| ADEO | | WATER I | DIVISION I | N | SP | EC | TION | I RE | PORT |
| Anthony Forest Products Company | – Uı | rbana Sawmill | FACILITY TYPE: 2 - Industrial | 1 | ISPECTO 015 | | State | | |

RE: Anthony Forest Products Company, LLC Compliance Inspection Response AFIN: 70-00473
 NPDES Permit No. AR0047384, Permit Tracking No. ARR000977, Permit Tracking No. ARG550398, and Permit Tracking No. ARG550540

Attachment 3 Outfall 003 Photos

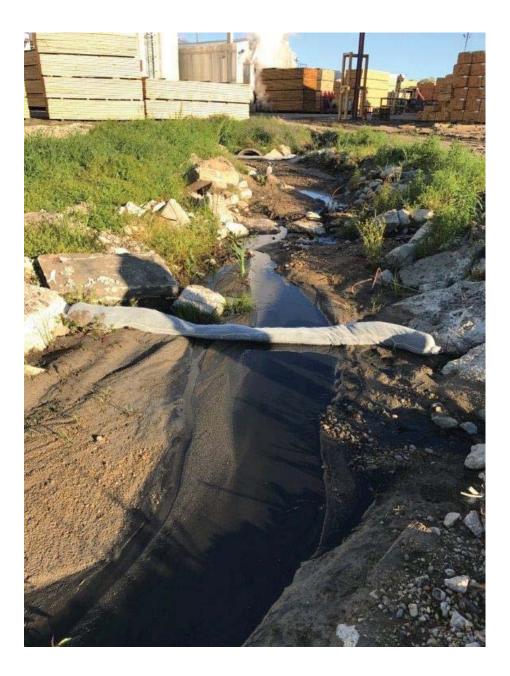
Oil sheen was observed in the ditch draining to Outfall 003 from the kiln area. The facility needs to adequately use good housekeeping measures and maintain all equipment to prevent the discharge of pollutants in stormwater discharged to receiving waters.

Oil booms have been placed in the drainage ditch leading to Outfall 003, as can be seen in the picture found in Attachment 3. The kiln area and drainage ditch leading to Outfall 003 will be monitored weekly by the EHS manager to ensure good housekeeping practices are being maintained and the oil booms are properly maintained.

Photograph showing oils booms that were placed in the drainage ditch leading to Outfall 003.
